UNITED STATES PATENT AND TRADEMARK OFFICE

Office Action Summary	Application No. 10/784,895	Applicant(s) DIERICHs ET AL.	
	Examiner Rodney E. Fuller	Art Unit 2851

DETAILED ACTION

Pierrat - Figure 2

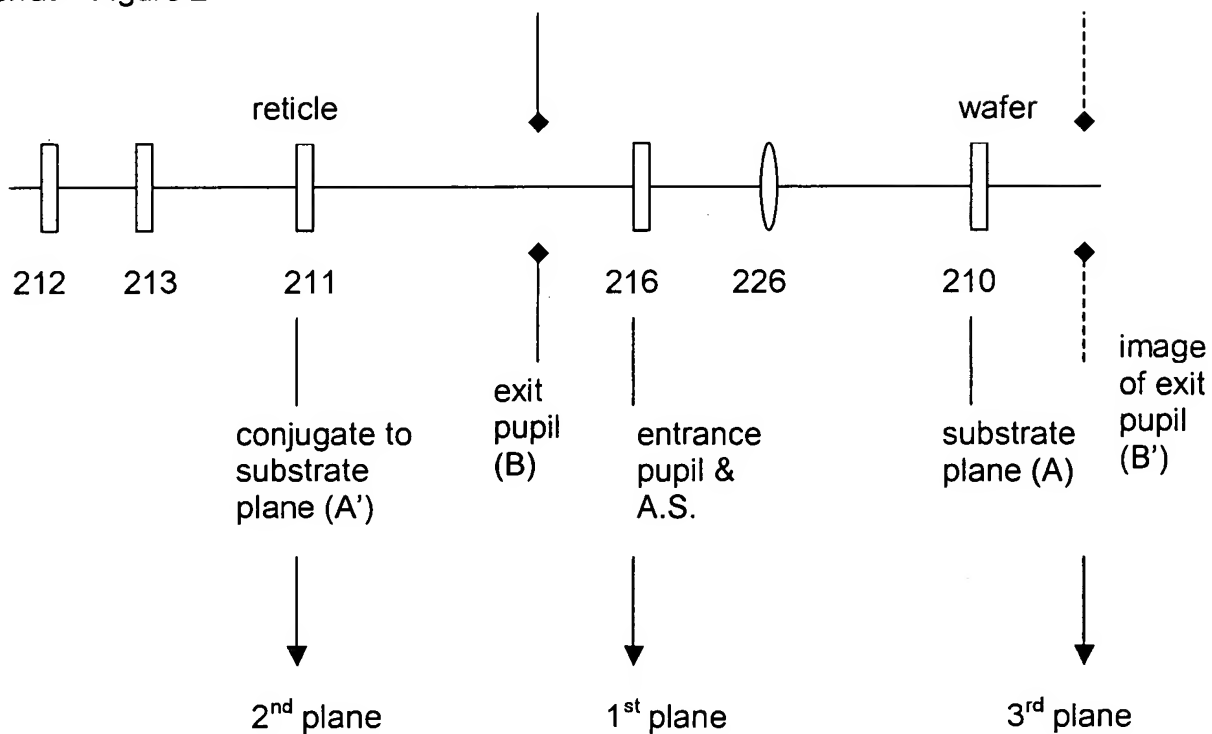
Regarding the 35 U.S.C. 102(b) rejection of claims 1 and 12 as being anticipated by Pierrat (US 6,040,892), the applicant makes the argument that "as clearly shown in Figure 2 of Pierrat, the aperture blades 216, 218, 220 and 222 are clearly positioned in a plane prior to the projection optics 226 and the wafer 210. Therefore, the aperture blades are not in a first plane that is intermediate a second conjugate to a plane of the wafer 210 and a third plane conjugate to the pupil pane of the projection optics 226."

For proper imaging in any optical system, the reticle (211) is located at a conjugate plane to the wafer (210). Thus, the "2nd plane" is conjugate to a plane of the

substrate. Given that the aperture (216) is located before the lens (226), the aperture will act as the aperture stop and as the entrance pupil of the lens. Further, the exit pupil will be located to the left of the aperture. (See Hecht, Optics, p. 150) An image of the exit pupil utilizing the lens (226) would result an image located to the right of the lens. Therefore, a conjugate plane to a pupil plane of the projection system is located to the right of the aperture. Thus, the examiner maintains that Pierrat does disclose " a device positioned in a first plane intermediate a second plane conjugate to a plane of the substrate and a third plane conjugate to a pupil plane of the projection system."
